VCOM Firmware Chip Retrofit

Removal and Replacement of the VeriComm[®] Firmware Chip for IP-Compatible Control Panels

Step 1: Open the Panel

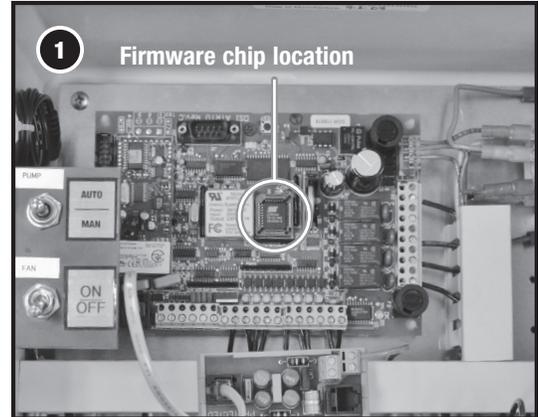
Open the control panel and turn off the breakers. Confirm that the panel has black MOV terminal blocks. Locate the firmware chip and check the firmware chip for a green dot. If the chip does not have a green dot, continue to the next step.

Step 2: Remove the Old Firmware Chip

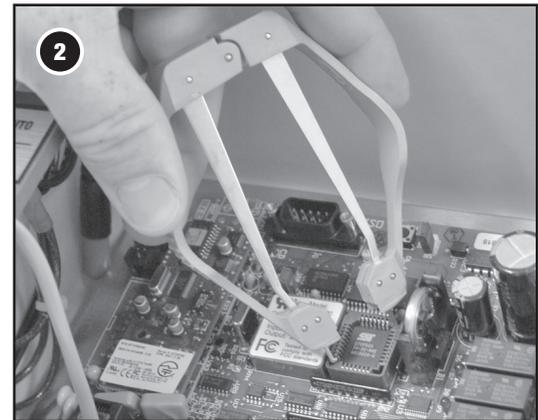
The socket for the firmware chip has two slots in diagonal corners for removing the chip. Use an extraction tool (supplied by Orenco) in the socket slots to gently remove the firmware chip from the socket. Be very careful not to damage the socket or bend the board while removing the chip.

Step 3: Install the New Firmware Chip

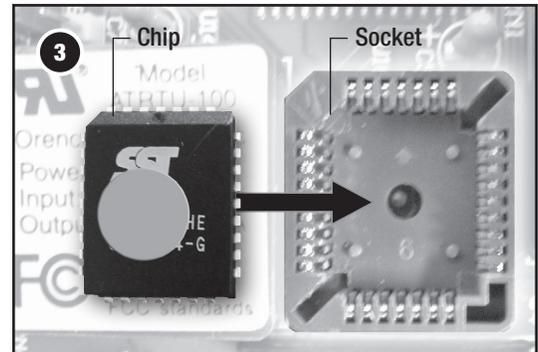
The new chip fits into the socket only one way. Gently position the new chip on the socket, with the writing and the green dot facing out. Using your thumb, evenly and firmly press the chip into the socket. You will feel and hear it click into place.
